Subject: **Modification Request for Section 404 Individual Permit, Individual Section 401 Water Quality Certification, Neuse Buffer Authorization, and Issuance of Tar-Pamlico Buffer Authorization** for the Rolesville Bypass from NC 96 (Zebulon Road) to SR 1103 (Flat Rock Church Road/Clifton Pond Road), Wake/Franklin Counties, Federal Aid No. STP-401(249), State Project No. 81403001, Division 5, TIP R-2814 C. Debit \$570.00 from WBS Element 34506.1.1.

Reference: Section 404 Individual Permit, issued July 14, 2009, USACE Action ID 2008-01316

The permits stated above only approved preliminary impacts for Section C. Section C now has final design. The purpose of this submittal is to request a modification to the Section 404 permit, Section 401 Water Quality Certification and Neuse Buffer Authorization for Section C. The permit package consists of the cover letter, Hydraulic Review (Concurrence Point 4B and 4C) meeting minutes for Section C, N.C. Division of Mitigation Services (DMS) acceptance letter, Stormwater Management Plan, utility drawings, permit drawings, and roadway plan sheets.

PROJECT REFERENCE NO.	SHEET NO.
R-2814C	23
R/W SHEET NO.	
ROADWAY DESIGN ENGINEER	HYDRAULICS ENGINEER
PRELIMINARY PLANS DO NOT USE FOR CONSTRUCTION	
DOCUMENT NOT CONSIDERED FINAL UNLESS ALL SIGNATURES COMPLETED

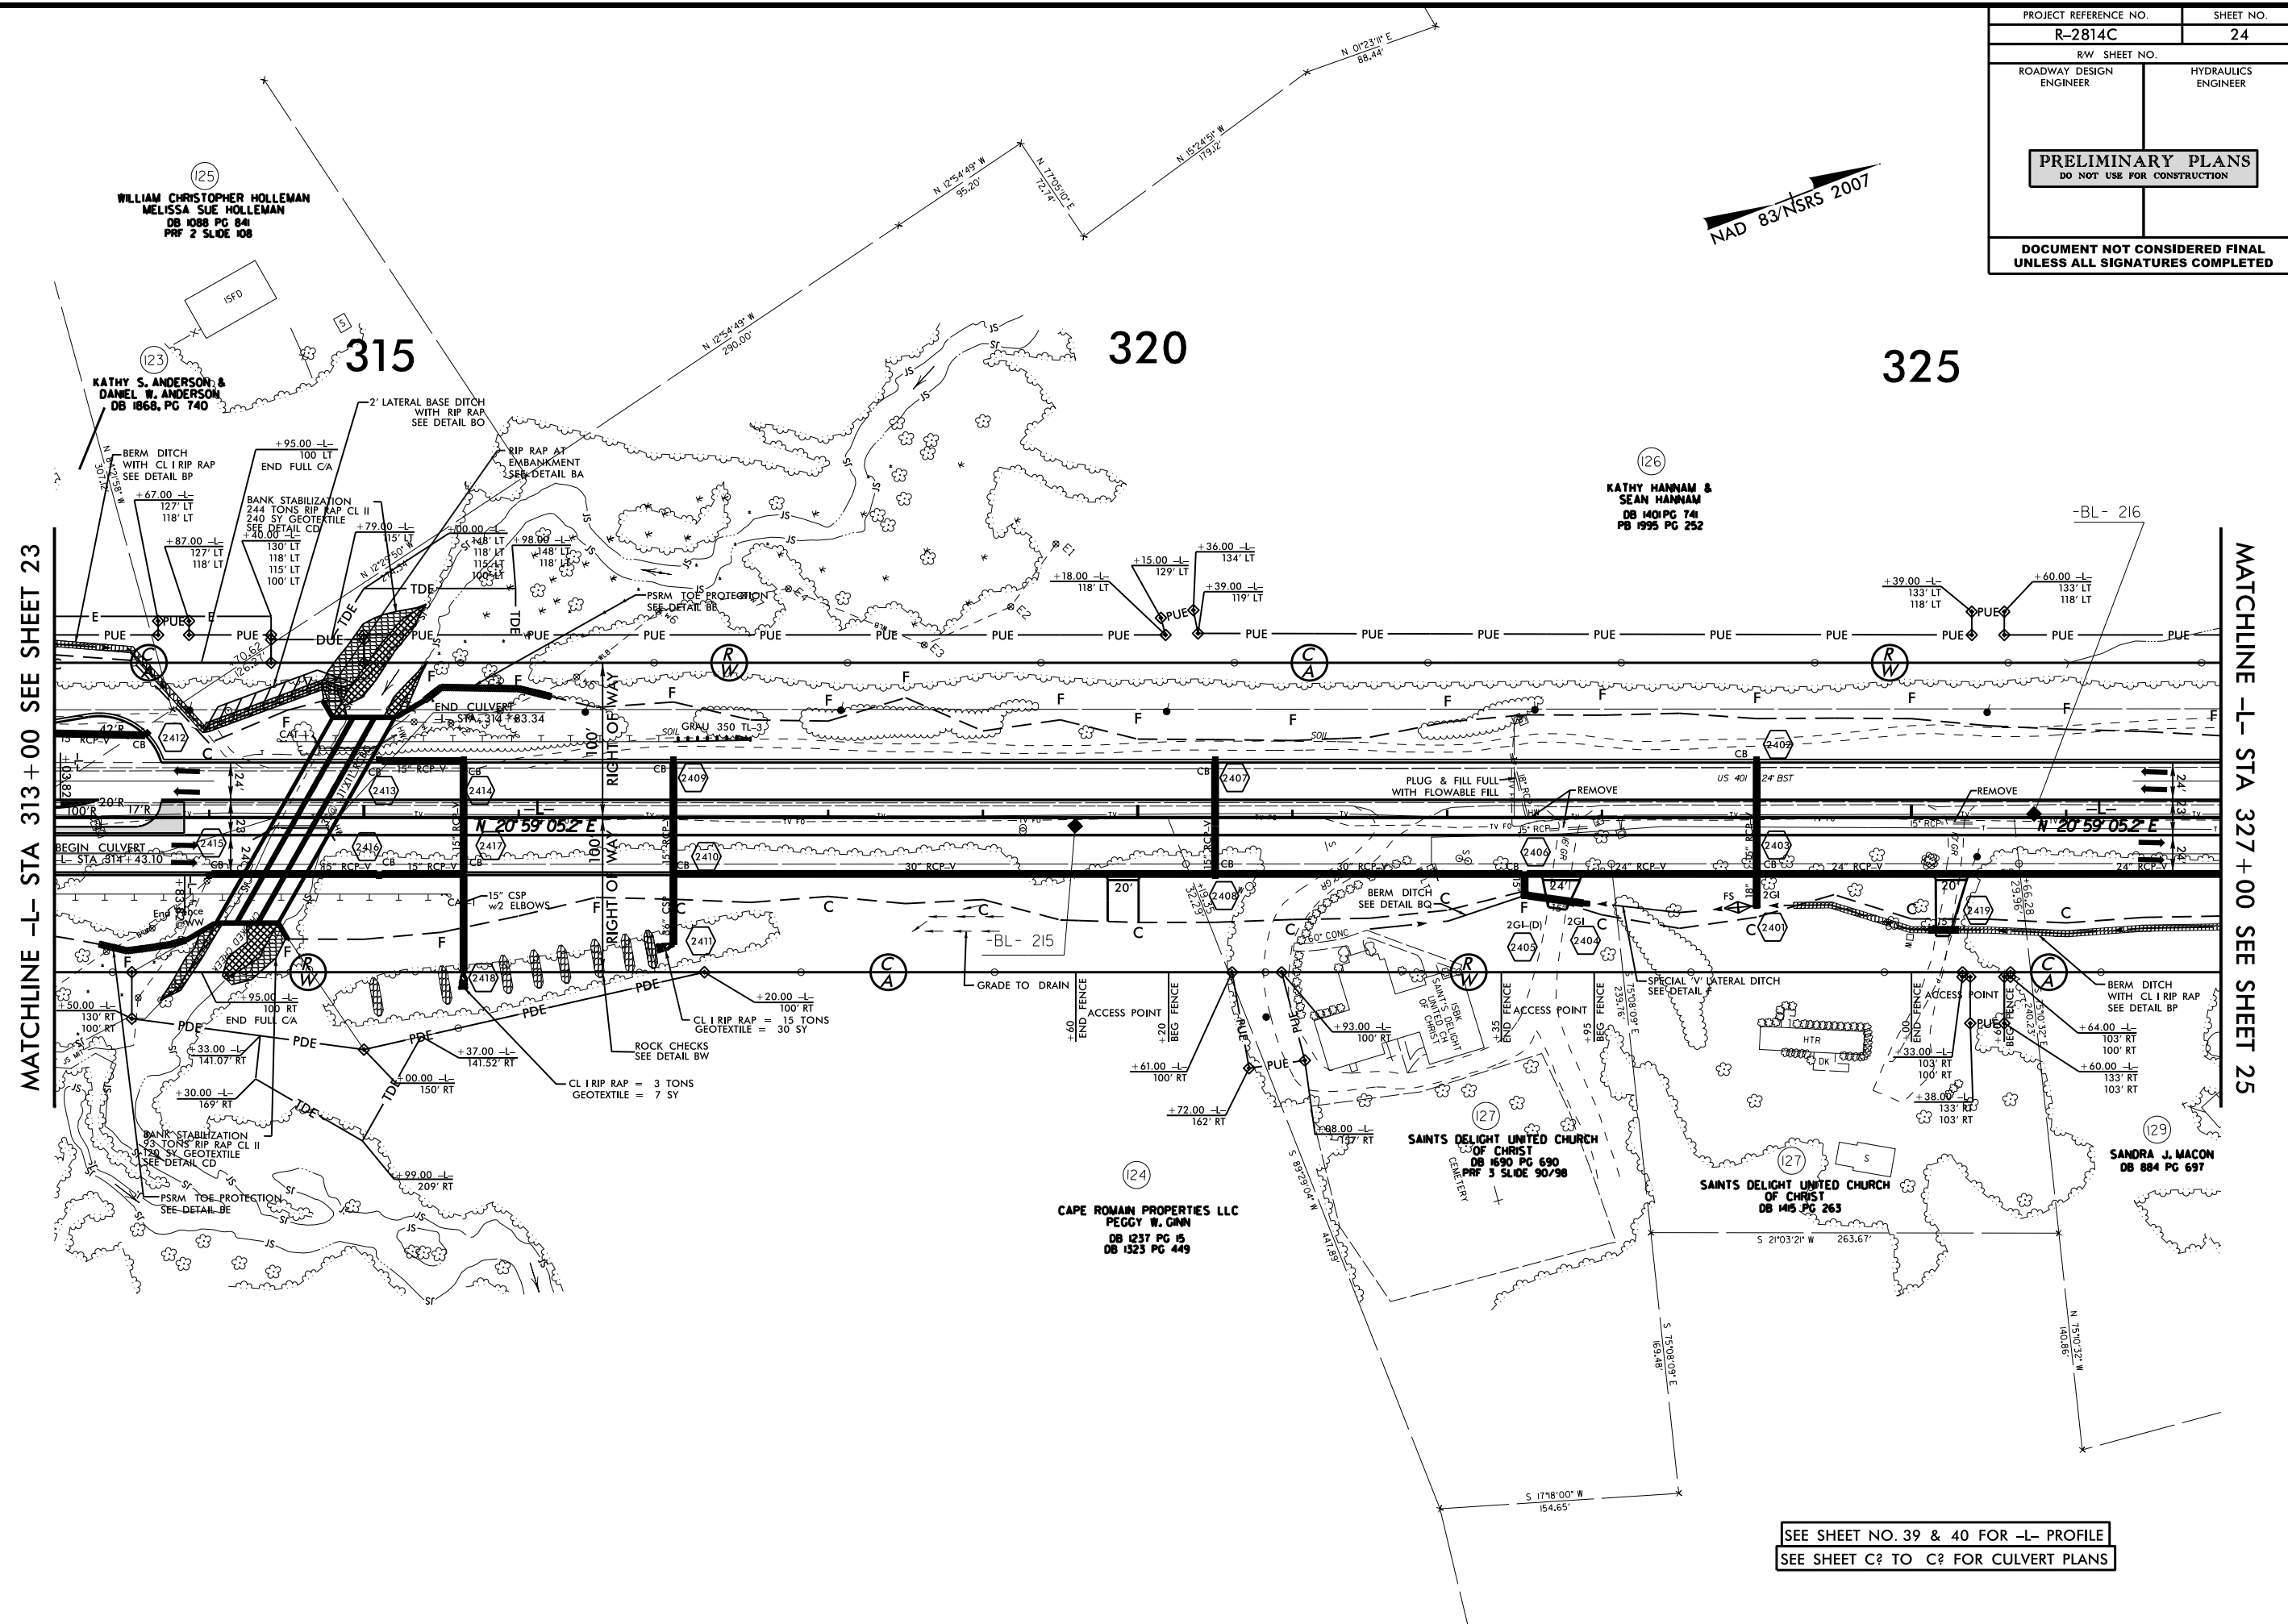
Jurisdictional stream 35A crosses the proposed roadway at -L- Sta. 307+60. There are concerns with the soil quality at the proposed outlet location if we excavate the upland to be the new stream bed. The concerns include not knowing how these upland soils will behave once exposed to water and erosive forces. The proposed cross pipe outlet end will either be adjusted to line up with the existing JS at the fill slope or extended to meet the jurisdictional stream, 10 feet or so past the fill slope. Bank stabilization will also be added to the upstream opening of this crossing.

A spring box will be added near 306+25 Rt, where stream 35B seems to originate. A pipe will route this flow to the right fill slope to a lateral ditch to the main stream; stream 35A. Although jurisdictional stream 35B would be a total take for surface waters, it would not have to be a complete take of buffers on the right side only. The mitigation quantity could be lowered if we provide a lateral ditch outside the fill slope as planned, reforest right of the ditch and provide PDE. A cost analysis should be performed here to include land cost and cost of mitigation to know which design would be more cost effective.
